DEVELOPMENT REVIEW COMMITTEE (DRC) COMMENT REPORT

PROJECT NAME: 520 W Broward

CASE NUMBER: UDP-S22014

REQUEST: Site Plan Level II Review: 365 Multi-Family Residential Units and 2,500 Square-Foot of Commercial Use in the Downtown Regional Activity Center

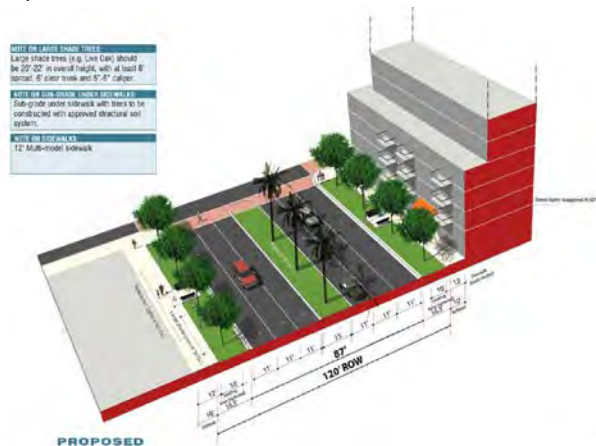
- i. Provide on-street parking design per the details and cross section below.
Edge of asphalt to building line = 26 feet. Within those 26 feet would be:
Sidewalk (multi-modal) = 12 feet.
Planting area (optional seating or other plaza-like elements) = 14 feet.
Planting should be placed so not to create issues with site visibility triangle.
